Department of Public Works
City Engineering Division

NOTICE OF ADDENDUM
ADDENDUM NO. 1
2013 PARK PLAYGROUND IMPROVEMENTS
CONTRACT NO. 7130

*2013 PARK
PLAYGROUND
IMPROVEMENTS*

1.3

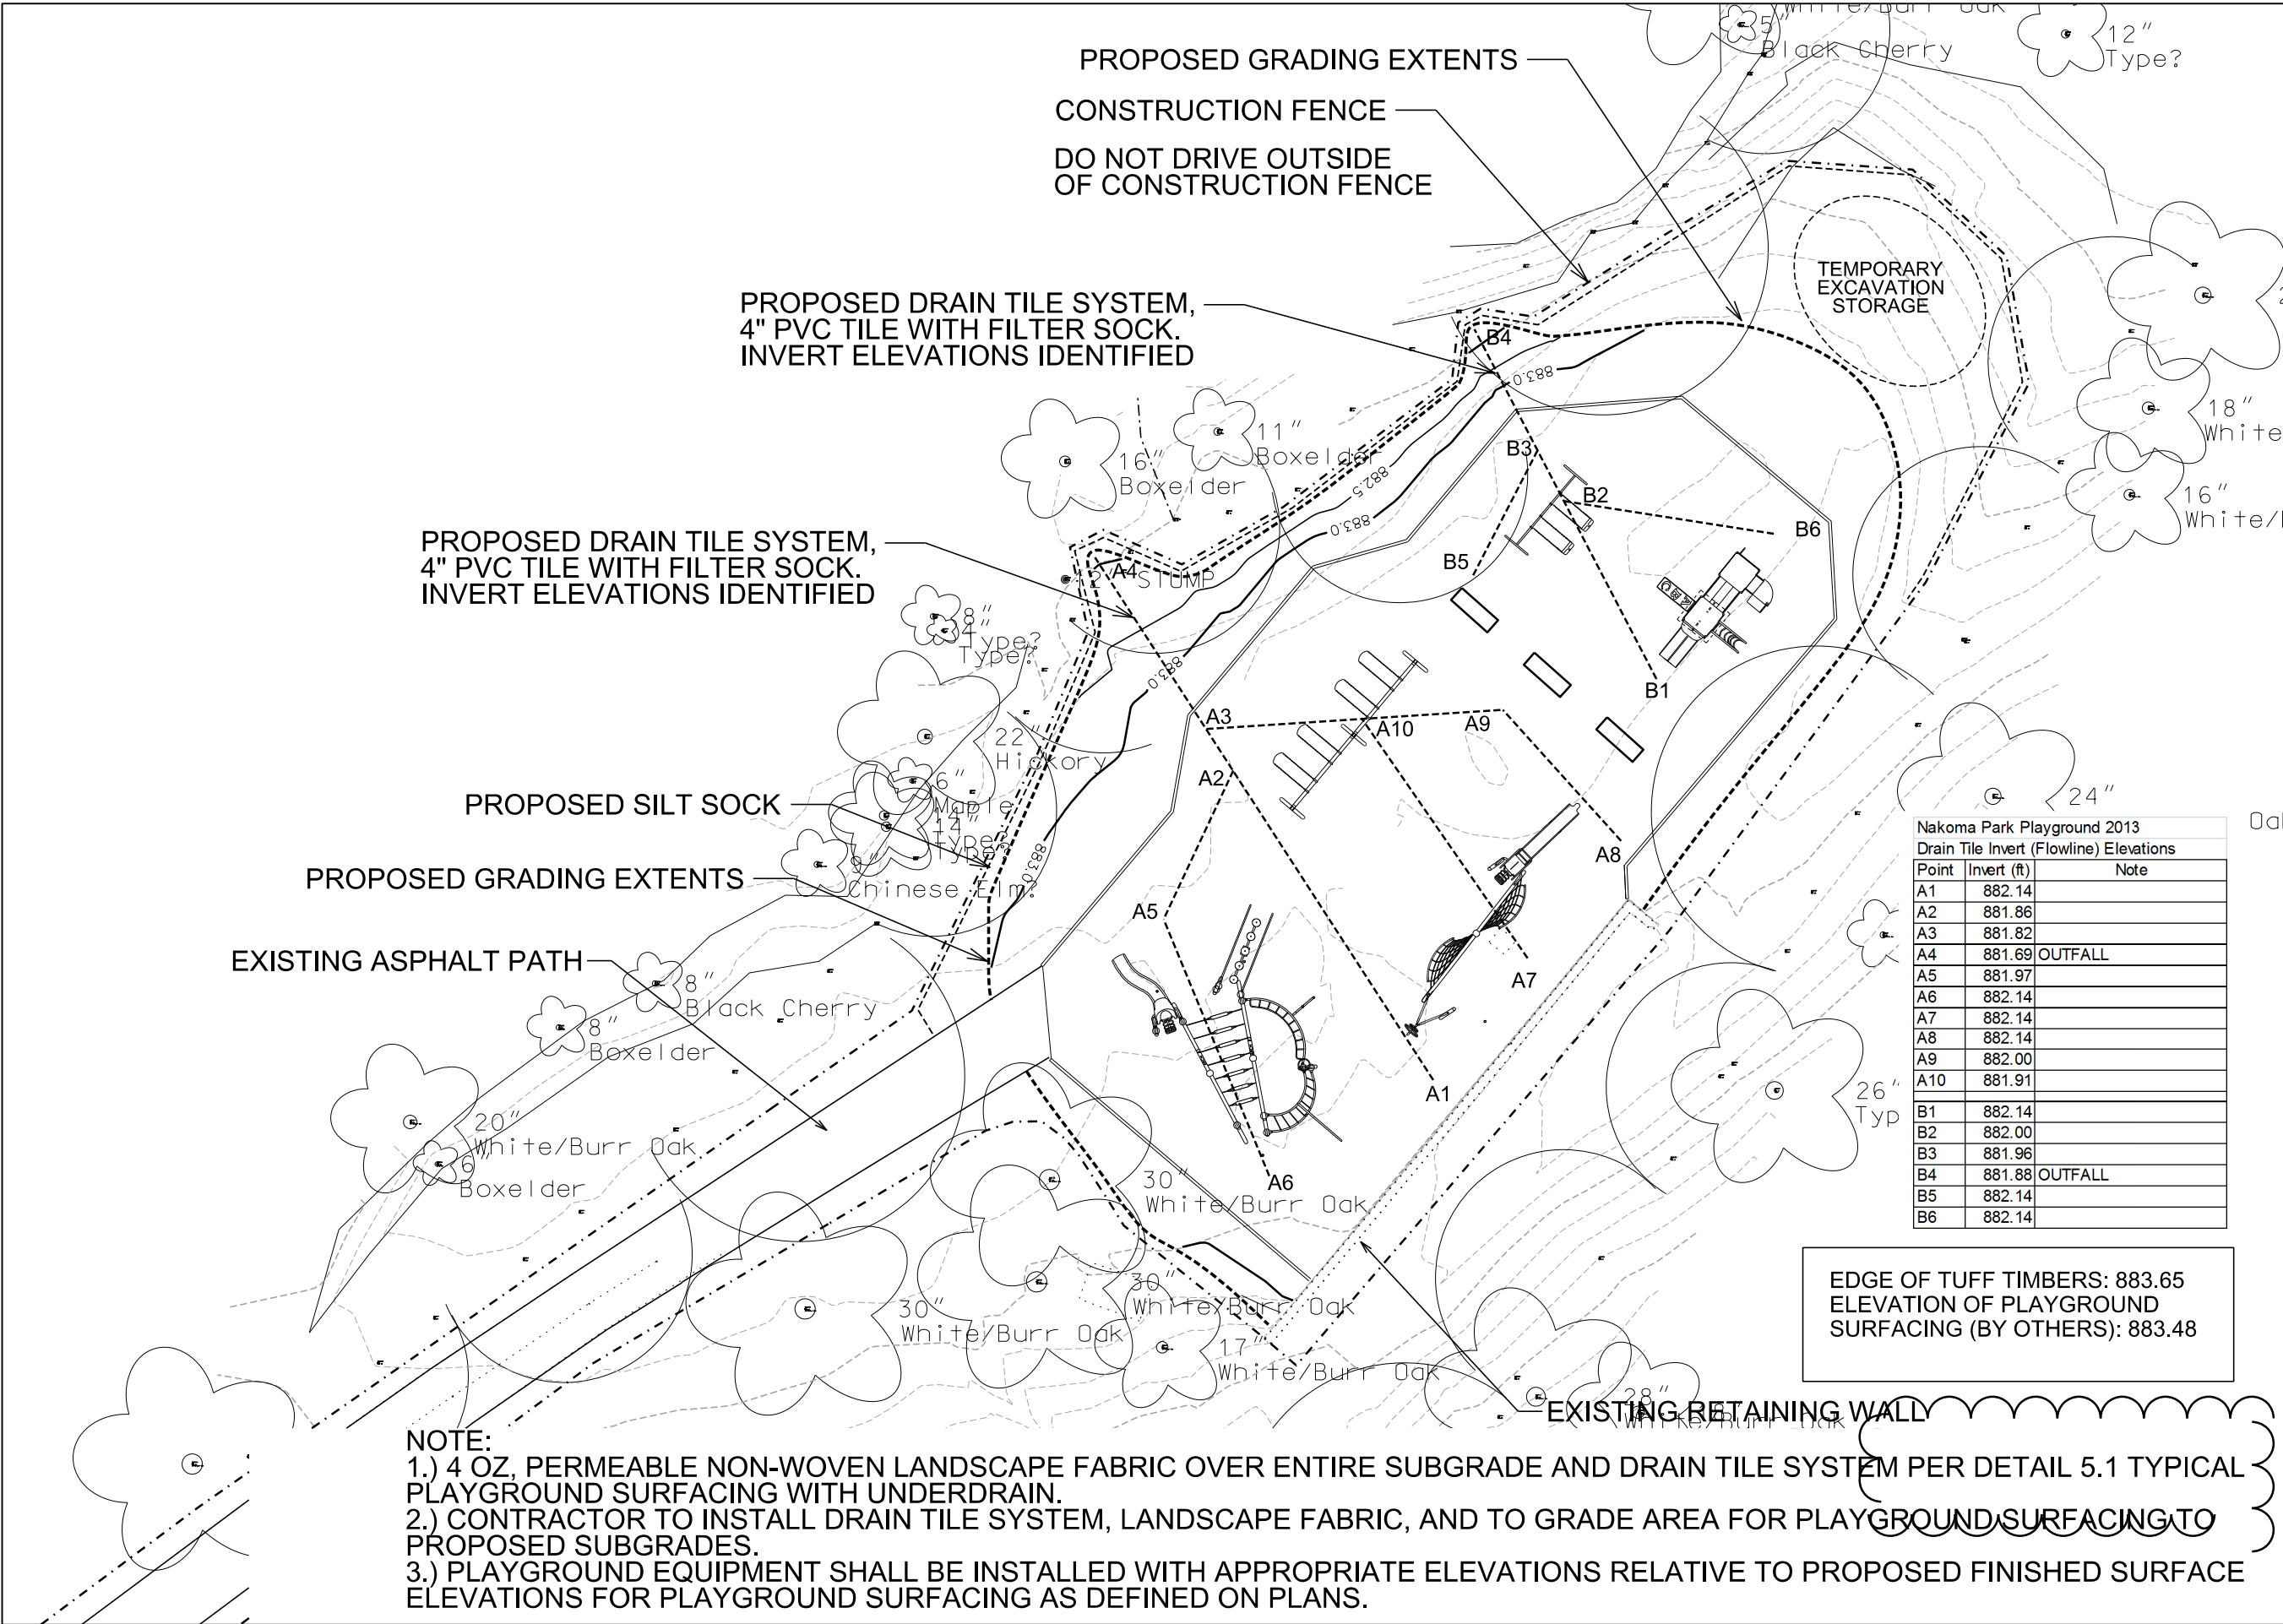
- Replace **COVER SHEET** of the **PLANS** with revised **COVER SHEET** dated July 9, 2013.
- Replace **Sheet 1.3** of the **PLANS** with revised **Sheet 1.3** dated July 9, 2013 and discard old sheet. The sheet is updated to include playground equipment name designations for **BID ITEMS 90007-90011**.
- **Replace Sheet 1.4**
- **Replace Sheet 2.2**
- **Replace Sheet 2.4**
- **Replace Sheet 2.5**
- **Replace Sheet 3.2**
- **Replace Sheet 3.4**
- **Replace Sheet 4.3**
- **Replace Sheet 4.6**
- **Replace Sheet 4.7**
- **Replace Sheet 5.2**
- **Add Sheet 5.3**
